NUMBER: 02-001-16

GROUP: Front Suspension

THIS BULLETIN SUPERSEDES SERVICE BULLETIN 02-008-15, DATED DECEMBER 16, 2015, WHICH SHOULD BE REMOVED FROM YOUR FILES. ALL REVISIONS ARE HIGHLIGHTED WITH **ASTERISKS**** AND INCLUDE THE REUSE OF THE U-BOLT.**

Vibration/Shimmy At Low Speed With 4 Inch Mopar Lift Kit Installed

Fig. 4 U Bolt

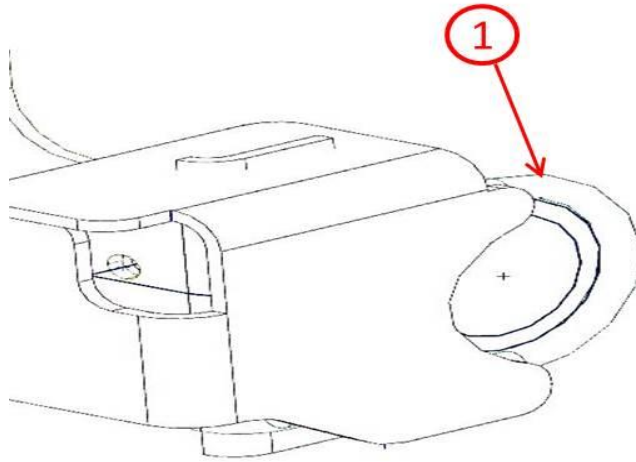
13. ****Install the U-bolt that was removed previously (1)**** on the bracket with the provided nuts (**Fig. 4**).
